# 1973 Corvette: Service Bulletin: Exhaust Manifold Heat Shielding

73-T-8

Subject: EXHAUST MANIFOLD HEAT SHIELD -  
 1973 CORVETTE WITH 350 CU. IN.  
 ENGINE WITH AIR CONDITIONING

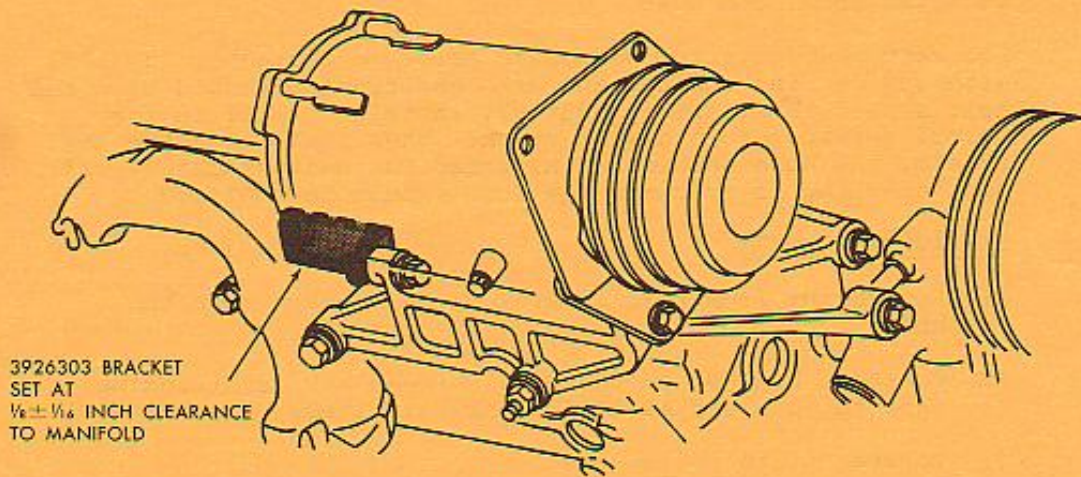
Some early production 1973 Corvettes equipped with 350 cu. in. engines and air conditioning may experience air conditioning hose damage due to close proximity of the exhaust manifold.

Corvettes assembled after September 13, 1972, have a heat shield installed between the hose and the manifold to protect the hose from heat.

For service, Corvettes assembled prior to September 13, 1972, with 350 cu. in. engines and air conditioning should have the heat shield, Part Number 3926303, installed while in for normal service or in dealer stock. When installing the heat shield, the hose should be inspected for heat cracking. If heat cracking is evident, the hose should be replaced.

- 1) Remove nut from rear compressor to bracket mounting bolt.
- 2) Position bracket on bolt and between air conditioning suction hose and manifold as illustrated.
- 3) Torque nut to 25 ft. lbs.
